To: Charlotte Wain
CC: Shauna Moore
From: Dave English
Date: February 11, 2021
Re: REZ No. 00683 & DP No. 000543 – 1468 Vancouver Street (975 & 983 Pandora Avenue)

CITY COMMENTS AND RESPONSES

Section through the ramp.

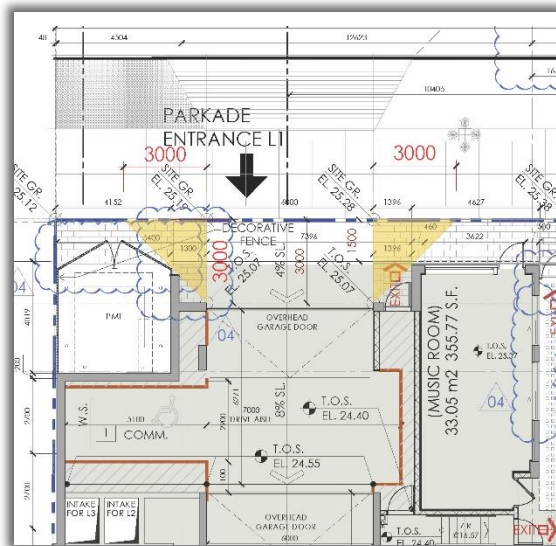
4. Overhead gates must be located 6.0 metres into the lot to avoid conflicts between pedestrians on the sidewalk and vehicles entering the parkade. A functional solution is required.
Variance requested due to specific site conditions. Because of the location, making the overhead gate deeper will cause challenges regarding:
Crime Prevention Through Environment Design.

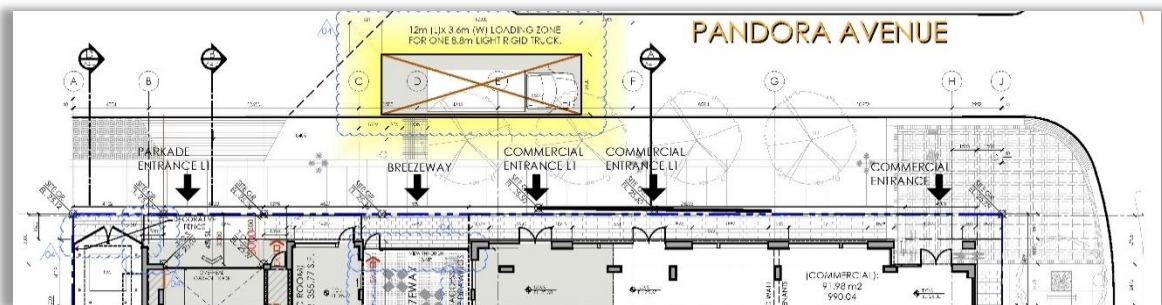
- As identified in the TIA, electric parking for both vehicle and bikes are important aspects of meeting the City's climate objectives. Please clarify what capability will be provided in the building to accommodate the anticipated demand.

1 circuit per 4 stalls. Load share on 40-amp circuit for residential stalls. Load sharing allows for 100% future EV capabilities.

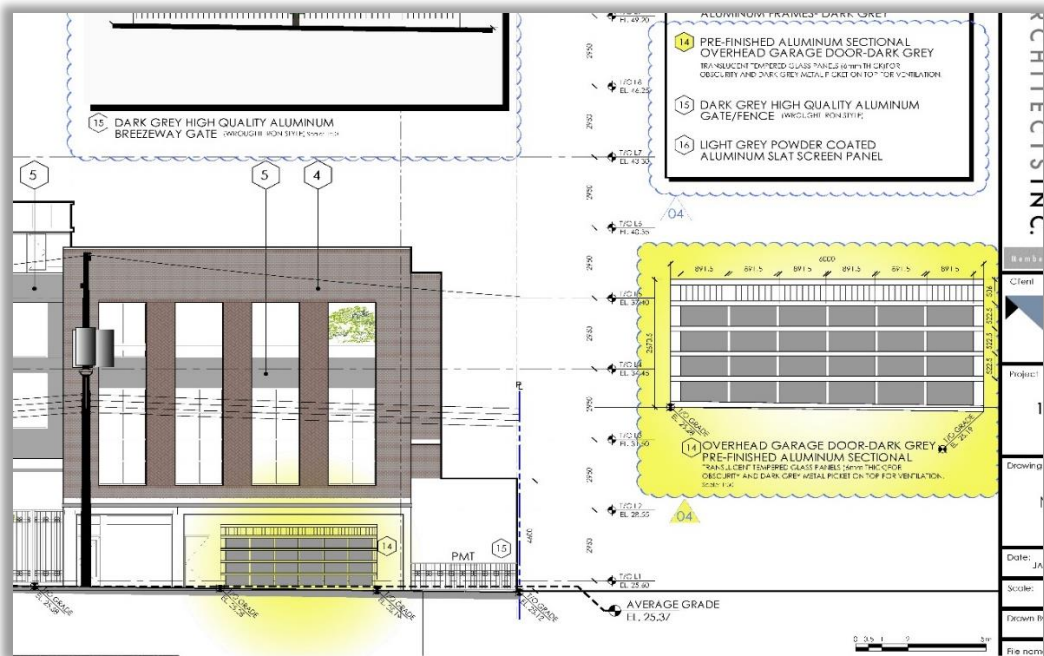
3. Amend the public realm improvements as per the attached sketch and add two bike racks in the boulevard along Vancouver Street as marked on the previous comments sketch (amend both the site plan and landscape plan). Note the attached sketch from Community Planning has also been approved by the Parks department.
[Complete. See sheet L-1.1.](#)
4. Clarify how the breezeway will function – the revisions letter mentions that direct access is required for loading and moving. Please confirm that no vehicle access will need to enter the breezeway.
[Confirmed no vehicular access through the breezeway. We have agreed with City staff that the loading will occur streetside and the pathway in the public realm will allow for convenient move in and move out.](#)

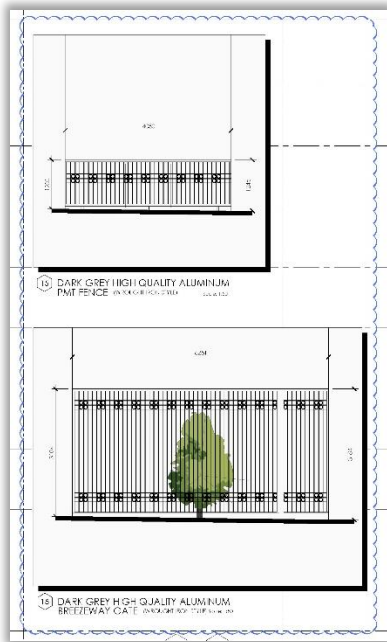
- Provide greater detail of the PMT fencing. This should be a custom fence consistent with the breezeway design. Include detail on drawing A3-01.

Complete.

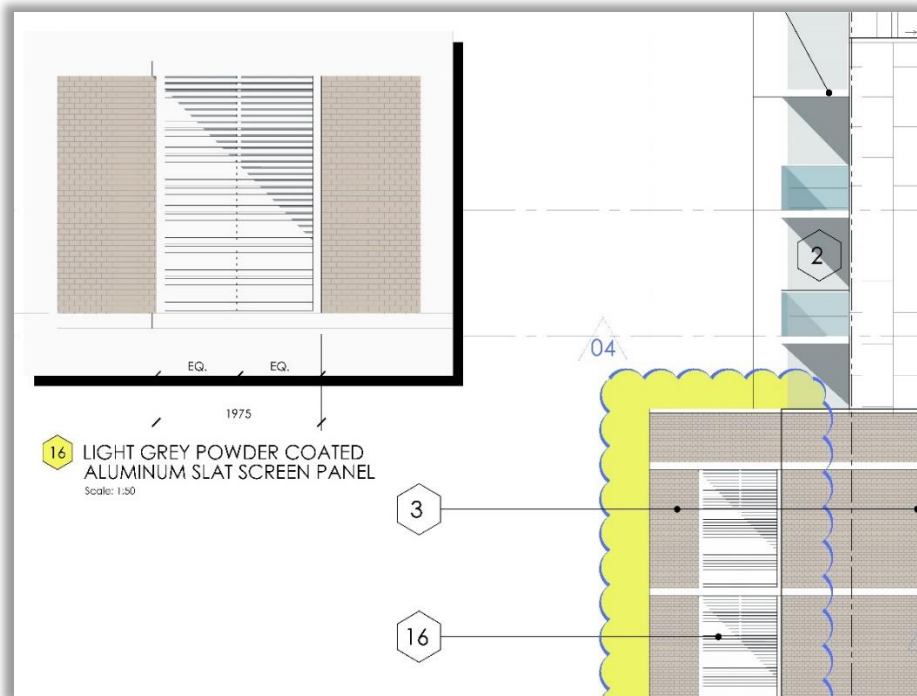
- Label the material for the balcony screening on the south elevation and provide a blow up of this detail (include on the elevation drawing A3-02). Note the elevation doesn't match the 3D render for the lower brick portion of this elevation.

Complete.
